**Environmental
Planning
Commission**

*Agenda Number: 06
Project Number: 1004167
Case #: 16EPC-40011
April 14, 2016*

Staff Report

Agent	James Strozier, Consensus Planning
Applicant	Paul Hedges, Guardian Storage
Request	Amendment to Site Development plan for Subdivision
Legal Description	1,2, 7A,8A,9 and 10B-2,, Bosque Plaza Subdivision
Location	La Orilla RD between Coors Boulevard and the Rio Grande
Size	11.5
Existing Zoning	C-1 (SC)
Proposed Zoning	Same

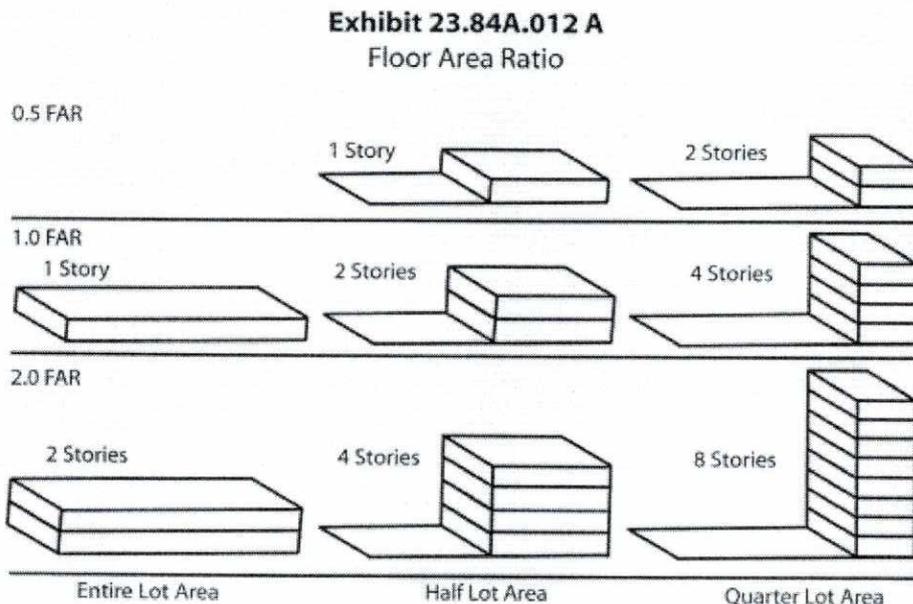
The Coors Corridor Plan (CCP) establishes a view plane at four feet above the elevation of the east edge of the east driving lane of Coors Boulevard. This view plane then extends at a 90 degree angle to the eastern boundary of the Corridor (page 103, CCP). The intent of the view plane is to preserve views to the Sandia Mountains and Bosque. The view plane provides a height cap for development within the view preservation area. The view plane building bulk (page 109) also requires that not more than 50% of the view area for any parcel on the east side of Coors be obscured by bulk of the building.

The elevation of Coors is approximately 5,016 feet above sea level at the western edge of the site. The view plane would be 5,020 feet above sea level. The elevation of the pad sites ranges from 4992 to 4996 feet above sea level at the eastern edge to between 5009 and 5011 feet above sea level at the western edge. Without a site development plan for building permit and grading plan it is difficult to

calculate a maximum allowable height for buildings on the site, but it seems that a 26 foot tall building could be developed at the east end of the site, depending on the final grading plan.

The plan allows a building to exceed the view plane by one third of its height (page 109).
